Supersedes SI0284 (514)

SI0284

OptiView Control Panel on Trane Chillers

Trane Tri-State Vane Actuator Replacement for Trane OptiView Retrofits

LD18187

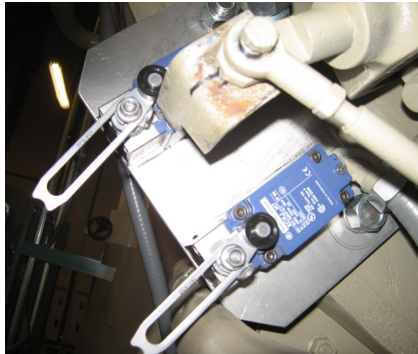
Competitive OptiView retrofits for Trane chillers require the Trane tri-state vane actuator (as shown below) in order to interface with the OptiView panel.

In mid-2013 Trane stopped supplying the tri-state vane actuator. To continue support of the Trane OptiView retrofits, we've identified and can source a tri-state style actuator. The use of this OEM actuator requires other unit modifications as noted below.

There are two major differences between the Trane tri-state vane actuator and our recommended replacement. First, the Trane actuator contains internal limit switches. The limit switches perform two functions. At the full open vane position the limit switch opens to remove the open signal from the actuator. Without the limit switch the actuator motor could continue to see voltage at the wide open vane position and eventually burn out. At the closed vane position the limit switch performs the same function while also giving an indication of closed vanes which allows the chiller to start without a load.

Correct Placement of Limit Switches

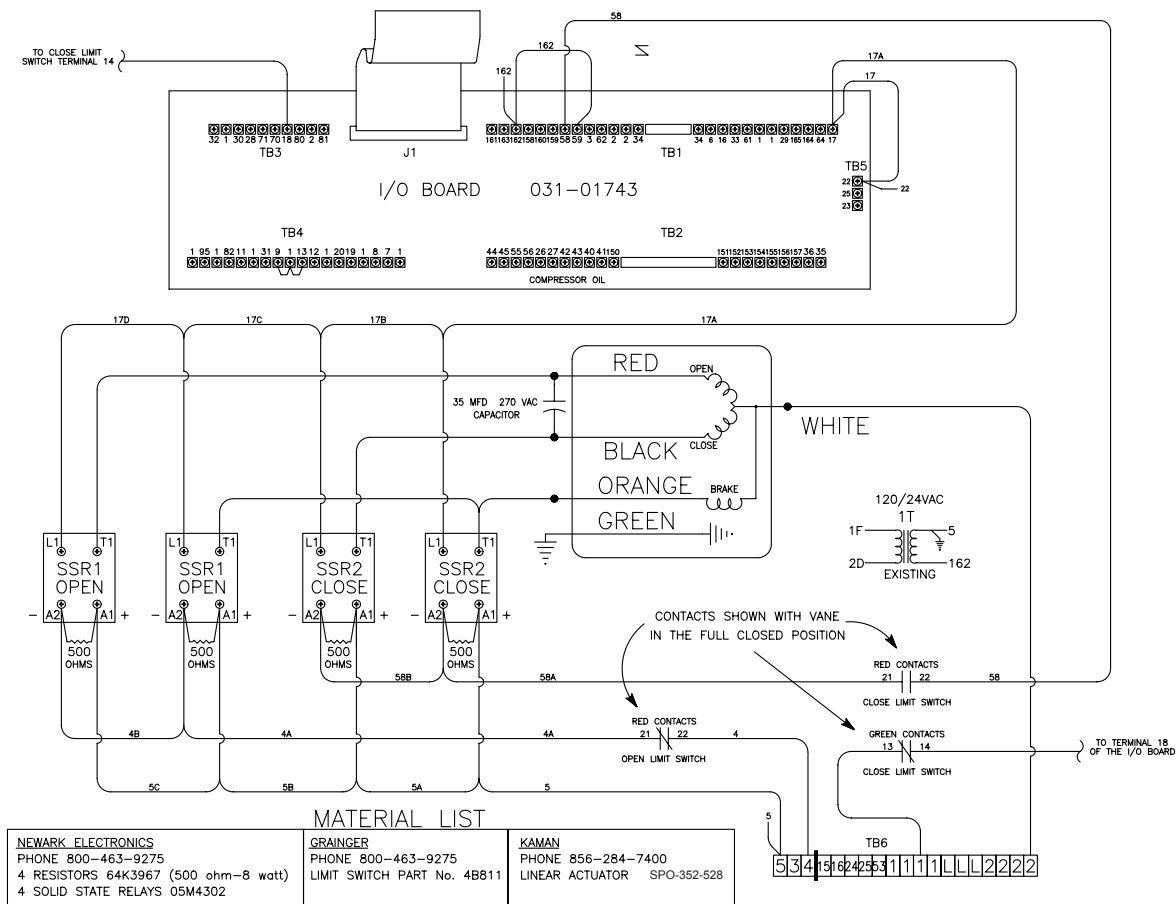
The replacement actuator requires the installation of two external limit switches, four relays, four resistors, and a field fabricated bracket. Connection of the vane linkage to the switches must be as noted below. Attachment of the vane linkage further out on the limit switch arm reduces the sensitivity of the switch and will cause issues with the switch incorrectly indicating full open or fully closed vane position. NOTE: Trane models CVHF may require minor grinding of the actuator arm where it fits into the Trane Vane Linkage (clevis) for proper fit.

Incorrect Placement of Limit Switches

LD18190

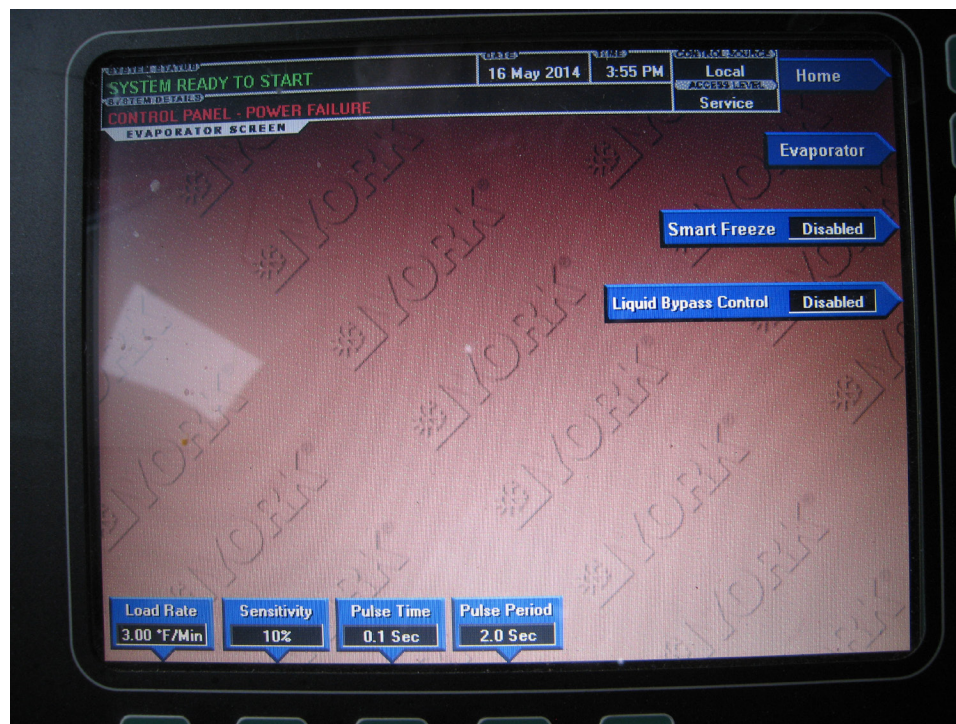
Wiring of the limit switches is as follows:
